### STAFF RECOMMENDATION

106 Cherokee Road

February 17, 2016

**Application:** New construction—addition and Outbuilding; Setback determination

**PROPOSED SITE PLAN**  
**PROPOSED HOUSE ADDITION**  
 106 CHEROKEE ROAD · NASHVILLE  
 FEBRUARY 2, 2016      REV. 5 FEB. 2016

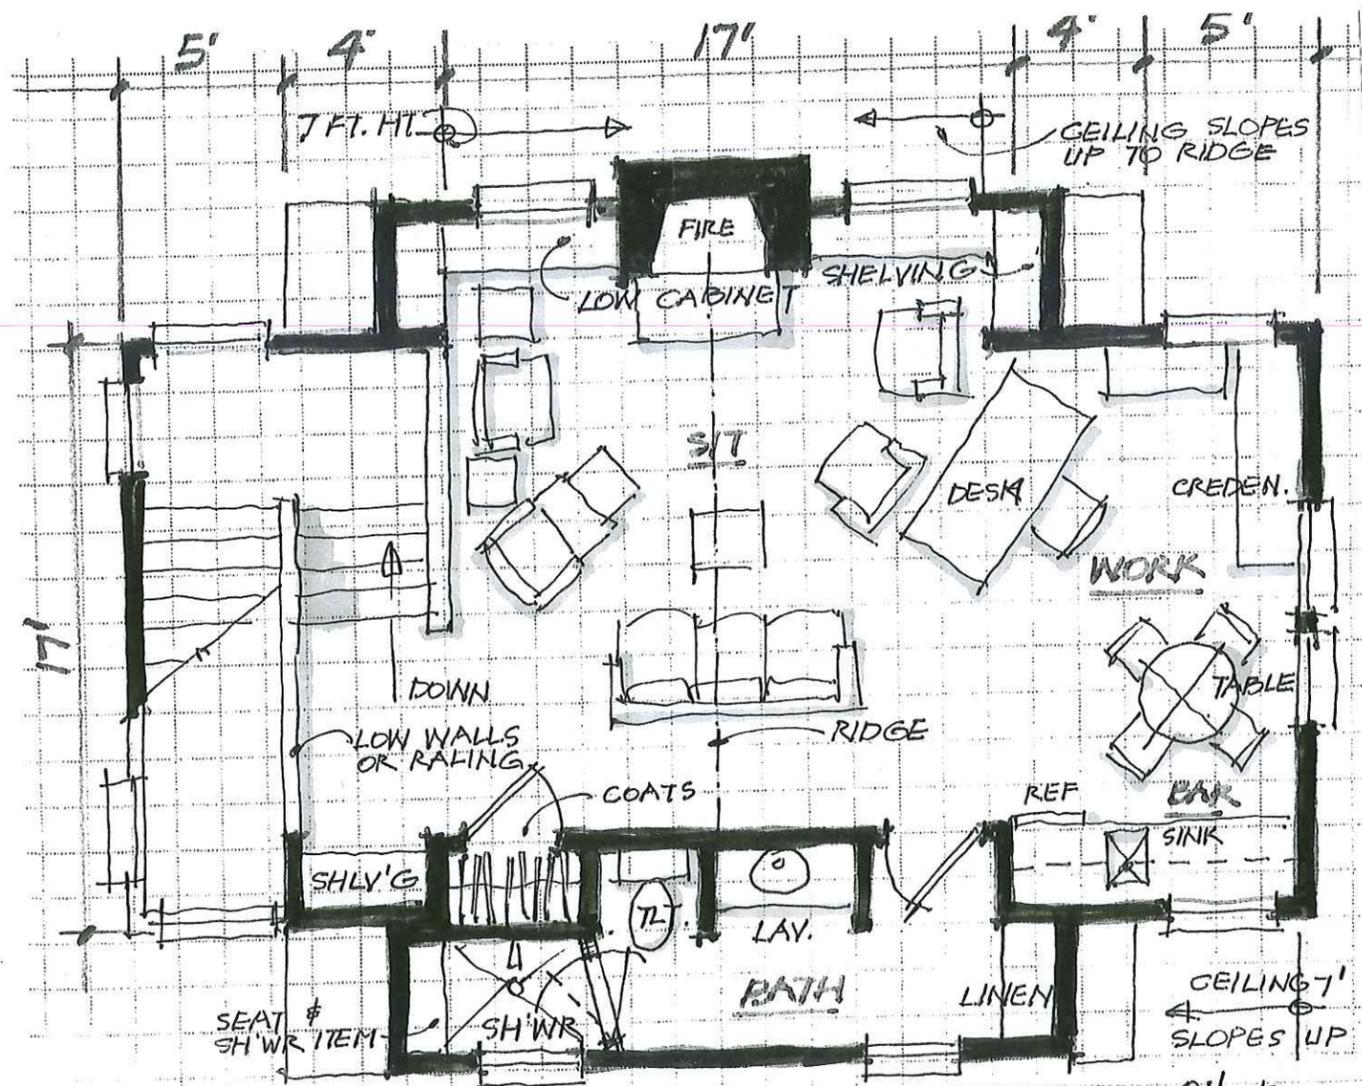
Setback & Rhythm of Spacing: The proposed addition will meet the side setback, but requires a setback determination for the rear. Base zoning requires a twenty-foot (20') rear setback determination, but the applicant is proposing to set the addition just seven feet (7') from the rear property line. The part of the addition that encroaches on the rear setback is the attached garage, and staff finds the setback to be appropriate in this instance because garages historically were located closer than twenty-feet (20') from the rear property line. In addition, the addition's footprint, height, and scale are otherwise subordinate to the historic structure. Staff finds that the proposed setbacks meet Sections II.B.1.c. and II.B.2. of the design guidelines.

**REAR ELEVATION**

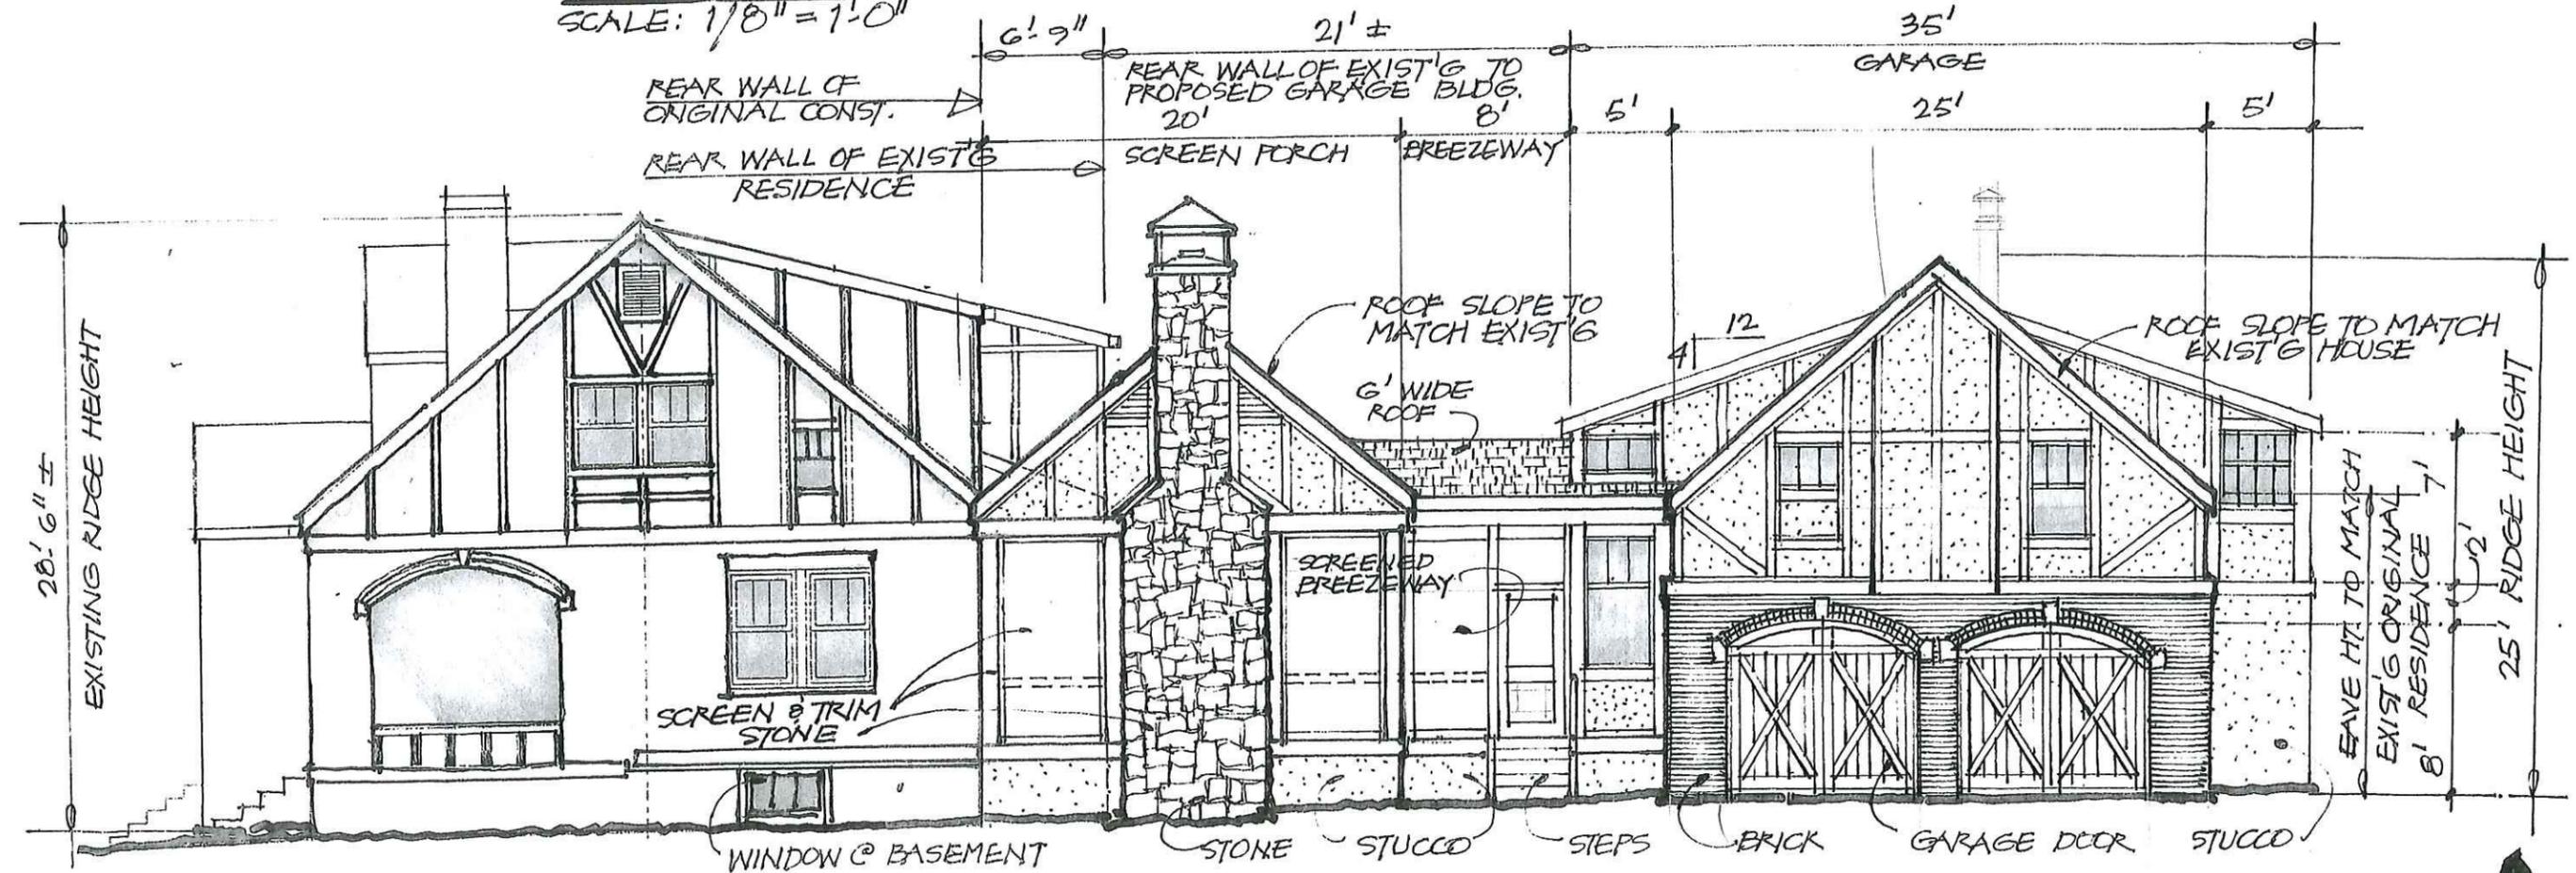
Roof form: The side addition and attached garage will have side gable roof forms in a slope that matches that of the historic house (which is approximately 10/12). The attached garage has a front and area-facing bays with shed roofs with a 4/12 slope. Staff finds that the proposed roof forms meet Sections II.B.1.e. and II.B.2. of the design guidelines.

In addition, staff recommends revising the italicized portion of the design guidelines to allow for attached garages on rear additions if the doors are located at the rear or step back from the side by at least 10'.
